Piper Aircraft Corporation

SERVICE LETTER

No. 648

Subject: Battery Ground Inspection and Modification

Relocated Ground Attachment Detail

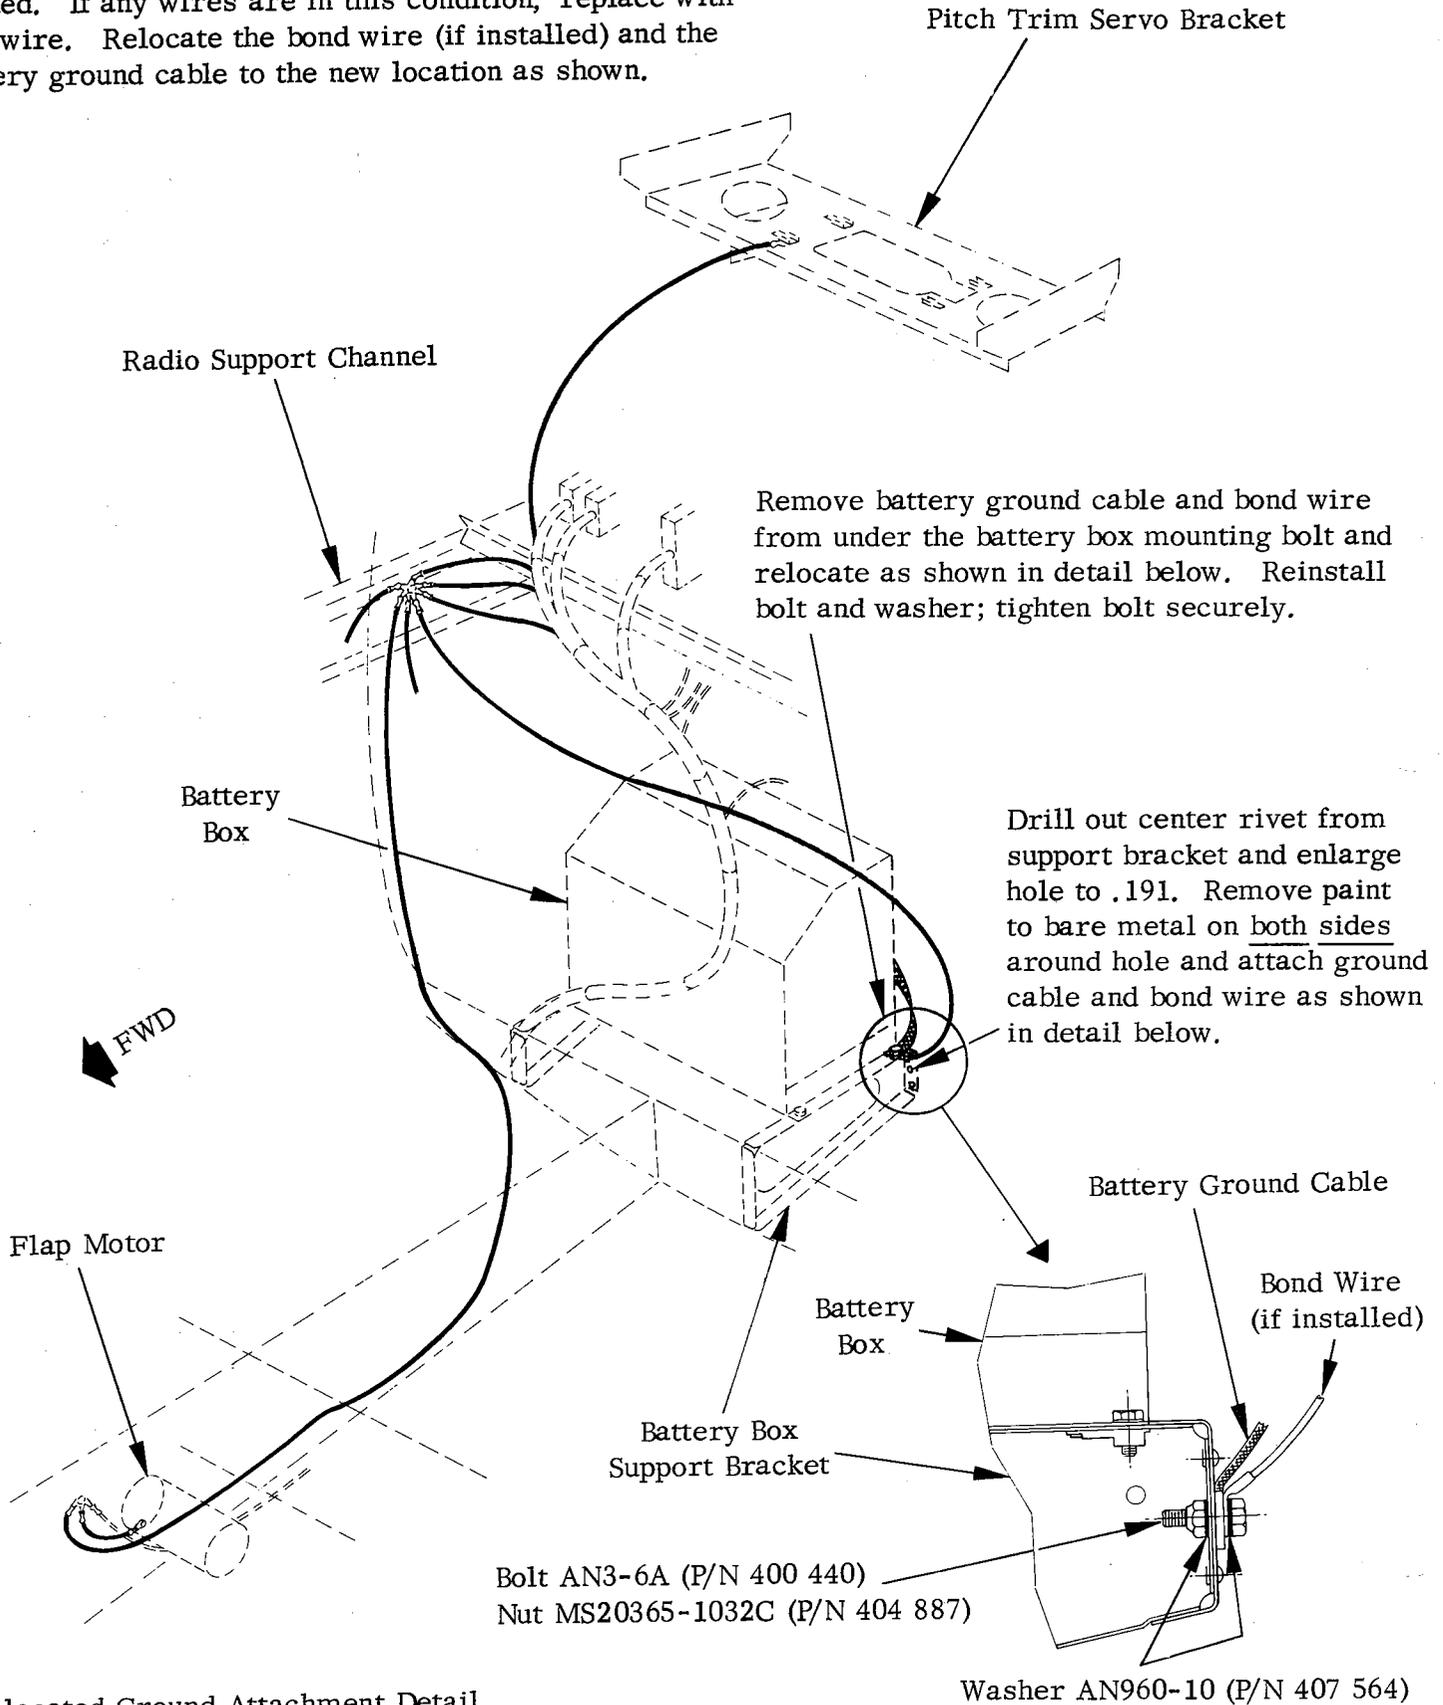
Purpose: A field report has been received describing damaged electrical wiring in the battery area -- in the form of scorched or burned wires. This condition was attributed to improper attachment security of the battery ground strap and bonding wire (if installed) to the battery box mounting bolt.

This service release provides instructions to inspect wires as shown in the sketch (on reverse side of this Letter) for indications of scorching or burning and to relocate the battery ground strap and bond wire (if installed) to a new location on the inboard battery box support bracket (refer to the sketch/instructions on the reverse side of this Letter).

Inspect all wires (indicated by solid lines) in the battery area for the possibility of any wires being scorched or burned. If any wires are in this condition, replace with new wire. Relocate the bond wire (if installed) and the battery ground cable to the new location as shown.
